**Application for Planning Permission**[click here for case file](#)

Reference	PA/20/01442/A1
Site	Walker House, 6-8 Boundary Street
Ward	Weavers
Proposal	Change of use of first floor office use (use class B1a) to 4no residential units (Use class C3). Construction of a two-storey building to the rear to provide office space (use class B1a)
Summary Recommendation	Grant planning permission with conditions and planning obligations
Applicant	Metro Associates
Architect/agent	GML Architects Ltd
Case Officer	Nicholas Jehan
Key dates	- Application registered as valid on 09/07/2020 - Public consultation finished on 09/09/2020

EXECUTIVE SUMMARY

Figure 4: Elevation Drawings of proposed scheme showing reduction in scale, height and mass of proposals as compared to the refused scheme (red dotted line)

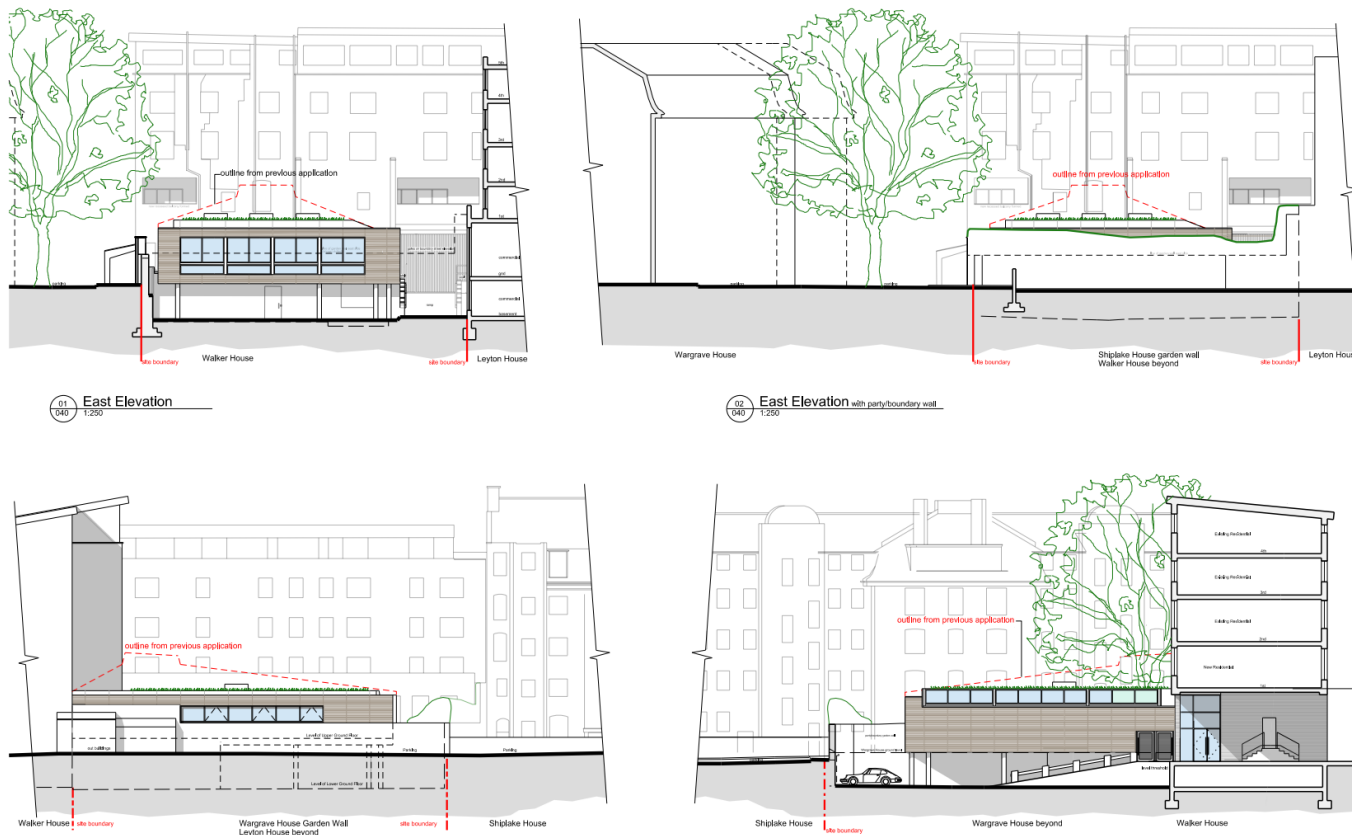
7.29 The reduction in scale, height and mass when compared to the previous scheme is further increased by moving away from the pitched roof profile in favour of a much simpler form with a new flat roof which significantly reduces the overall height, mass, and scale across the whole development and therefore its degree of presence to adjoining sites. Figure 4 below demonstrates the reduction in height and roof profile in plan form.

7.30 Whilst the proposed new building would be visible from upper floors of adjacent buildings, the reduction in height and simpler roof profile, and overall form, would mean the development would very largely be obscured from at grade views from the public realm by the existing boundary wall and accompanying greenery. Particular attention has been given to views from the Shiplake House Courtyard and from Boundary St (see images in Figures 8 to 13 below). When viewed from the entrance to Wargrave House, it is unlikely that the new building would be visible, given the significant soft landscaping already in place, only revealing itself as one moves into the space behind the listed buildings. The building sits slightly apart from the existing boundary walls and the roof has been further stepped back in addition, restricting views of the bulk of the development, and further minimising the visual impact of the building from surrounding areas. The reduction in mass has also improved the relationship between the new build and Walker House, when compared against the previous refused scheme.

Figure 23: Section of proposal with lower ground and ground of Leyton House (22 Calvert Avenue) on right. Outline of previous scheme indicated in red.

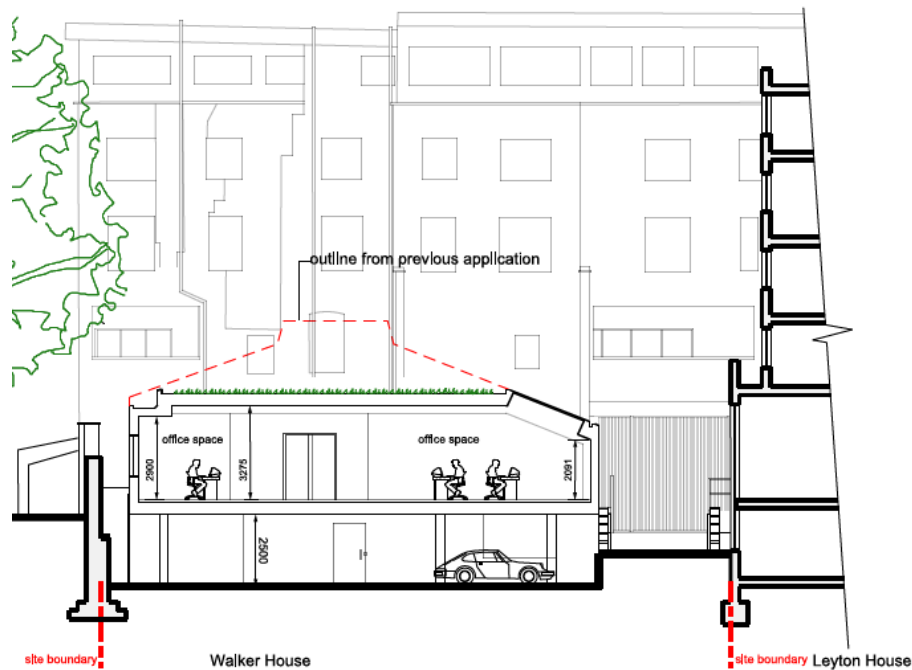
- 7.78 The proposal is set back from the adjoining Gainsbury and Whiting offices by approximately 4.5m and will maintain a reasonable level of daylight, sunlight, and outlook to these dual aspect premises. The lower ground floor windows of Leyton House are all obscure glazed and so do not provide any outlook for the occupants. The impact on those offices is further reduced by the removal of the pitched roof structure and the pitch of the proposed rooflights. The current proposals are seen as an improvement on the previous position which was deemed acceptable.
